To: Adam Grady, Hanover Site Design
From: Pat O'Mahony, Associate Planner; 910-341-0189
CC: File;
Date: 6/16/2020
Re: WESCP Building TRC Rev. 1

Site Plan Comments (Pat O'Mahony, Planning):

16. **SIGHT DISTANCE TRIANGLE FOR ANY STREET/DRIVEWAY INTERSECTIONS WITH THOROUGHFARES**

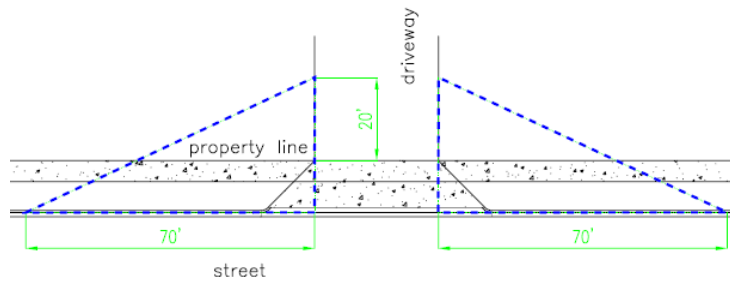
15. Dimension and label the City's 20'x70' sight distance triangle at each driveway on the site plan [Sec.18-529(c) (3) CofW LDC] [Sec. 18-812 CofW LDC].

17. S 16th and S 17th St is a major thoroughfare [Chap VII (C) (2) (a) of CofW Tech Stds]. In accordance with the City Code, sight distances along thoroughfares must be calculated in compliance with the AASHTO requirements. [Chap VII (C) (1) of CofW Tech Stds] [Sec.18-556 CofW LDC]. Show AASHTO in addition to 20'x70' SDT for driveways.
